RE: Bluewater Mill Site Reclamation Completion Report Comments
License No. SUA-1470, Docket No. 40-8902

Response to NRC's Comments

ADDENDUM 1
RESPONSE TO NRC COMMENTS

Figure 6-4 Ra226 Concentration in Soil Samples taken North of Exem

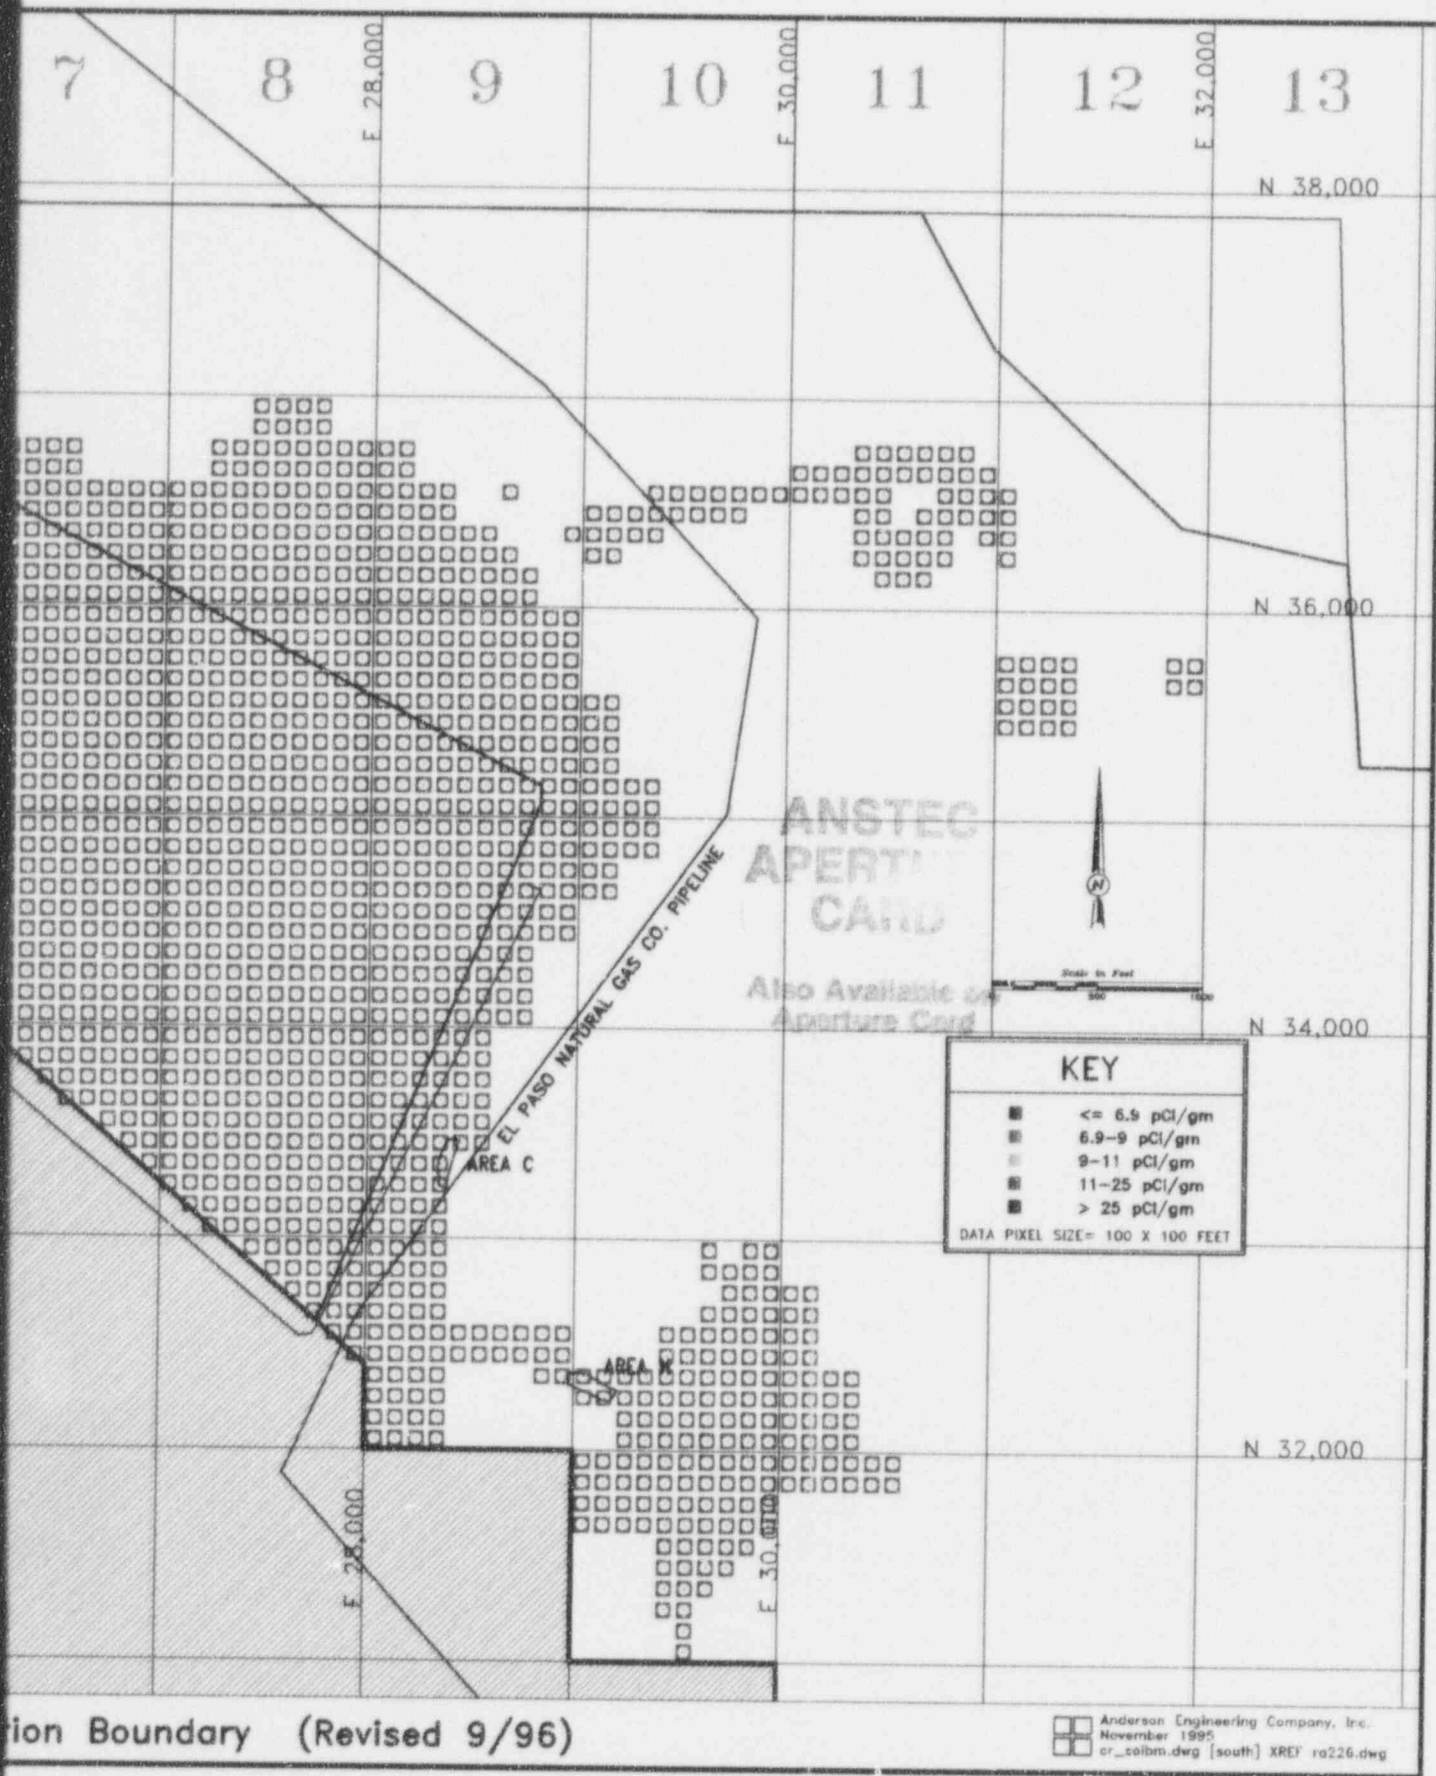
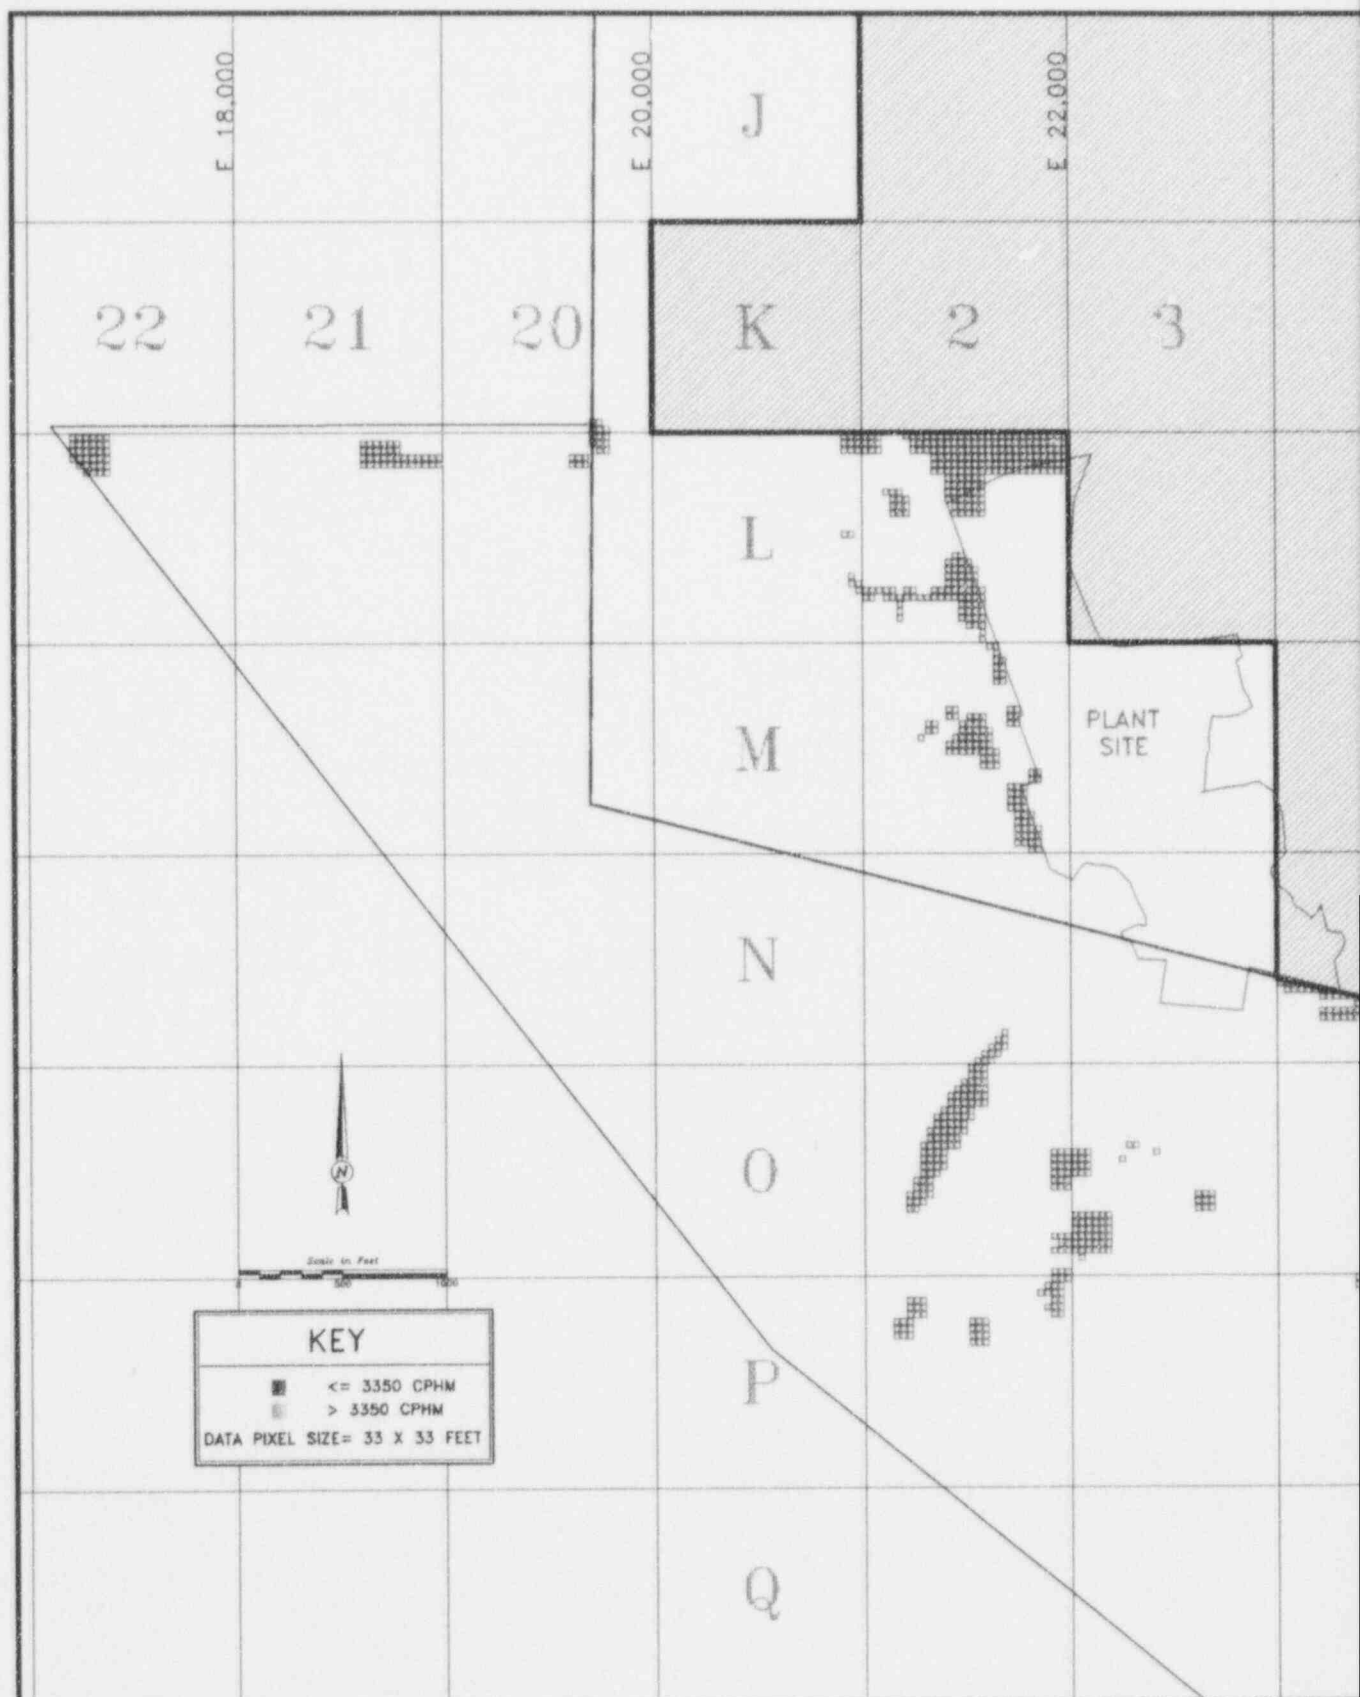
Figure 6-4 is missing Ra-226 data symbol for grids in block F12 and Ra-226 data is not in Appendix J, but gamma data is presented on Figure 6-3. ARCO should explain if this area was excavated.

Soil samples were collected in August 1996 at locations where Ra-226 data symbols were missing but gamma data was presented in grid block F12. This was one of the excavated areas and soil sampling was inadvertently missed. Figure 6-4 has been revised to incorporate the data and is included in Attachment 1. In addition, soil sample results for Ra-226 are included in Attachment 2 for inclusion in Appendix J of the CR.

Figure 6-5 Gamma-Ray Count Rate Measurements South of Exemption

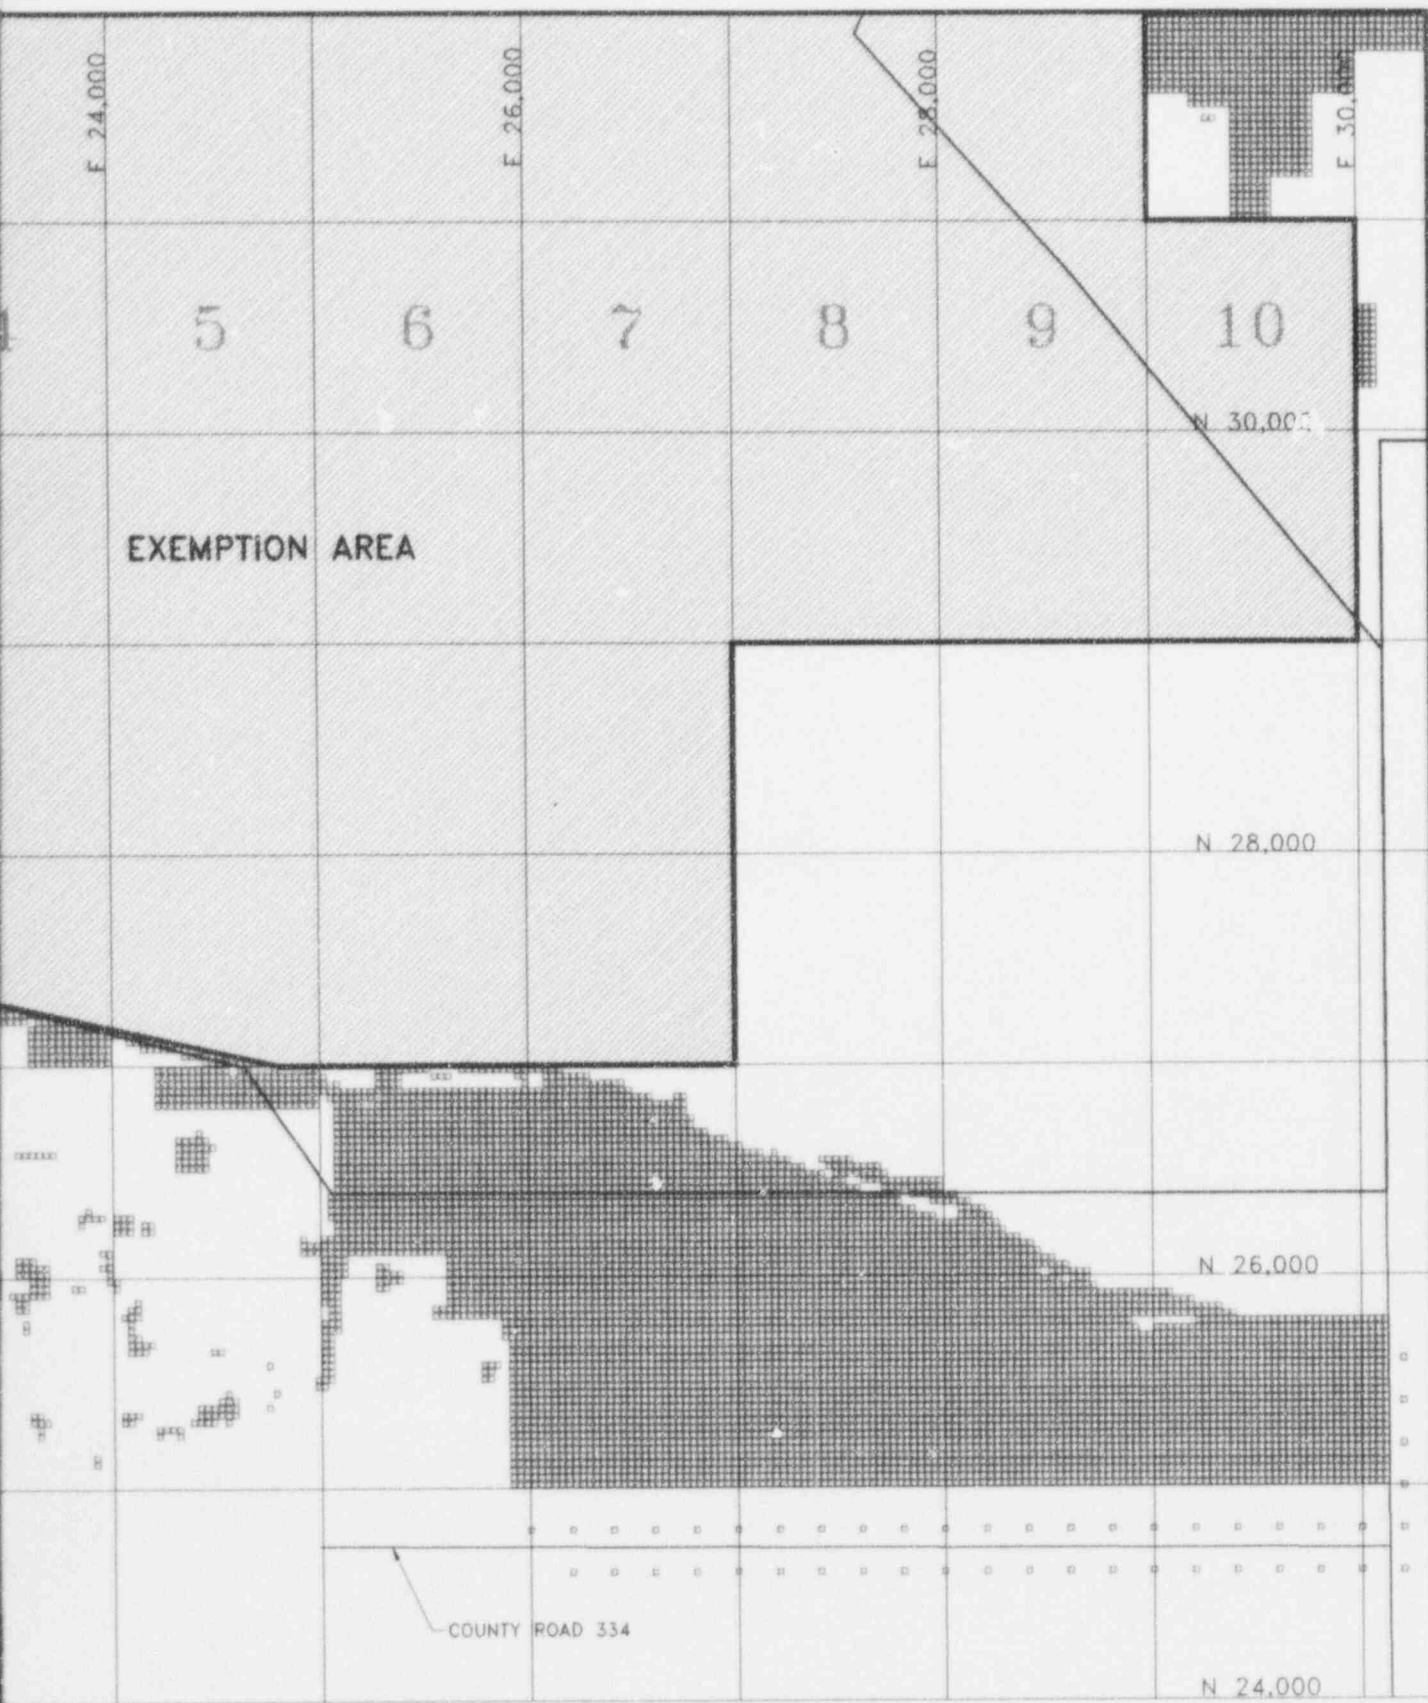
Page 82, second paragraph of Section 6.4, indicates that the area south of the exemption boundary meets the criteria, but ARCO should explain why Figure 6-5 indicates approximately 13 grids above the 3350 cphm action level. If these are the same grids mentioned at the bottom

The grid gamma readings stop abruptly at the Q block row. Indicate why there aren't readings for every 1000-foot grid (unaffected area, Figure 6-7) to demonstrate that no removal was necessary. The restricted area boundary is not a sufficient reason for lack of data.

Explain why Figure 6-6 indicates 3 soil samples in block K11, but there are no corresponding gamma readings in Figure 6-5.

The gamma data represented by color ranges on Figure 6-5 shows 12 grid blocks that exceeded the 3350 cphm gamma-ray action level. Those areas near the intersection of Grid Blocks N5 and O5, large piles of lava flow, exhibited elevated gamma count rates while not having any soil to sample. Other areas were sampled and found to meet the Ra-226 cleanup criteria.

Where gamma readings stopped at the Q block row is the southern edge of the golf course area. Gamma radiation surveys were conducted to characterize the golf course area as it was determined affected during the later stages of the Site reclamation. Isolated pockets of tailings material were identified in the golf course area, which appeared to be the result of golf course

construction activity by man, rather than windblown tailings contamination. Therefore, it is not expected to be beyond the golf course area. In addition, gamma radiation scan was conducted during the golf course area cleanup to assure boundary of contamination. Therefore, the gamma survey for cleanup verification was stopped at the Q block row. Nevertheless, a 200' grid gamma radiation survey was conducted in September 1996 which demonstrate that area south of the Q block row is unaffected. Revised Figure 6-5, included in Attachment 1, shows result of the September 1996 gamma survey.

The gamma radiation readings in Figure 6-5 corresponding to the soils samples in Figure 6-6 were inadvertently missed. The gamma radiation measurements were made at this location in August 1996, and Figure 6-5 has been revised and included in Attachment 1.
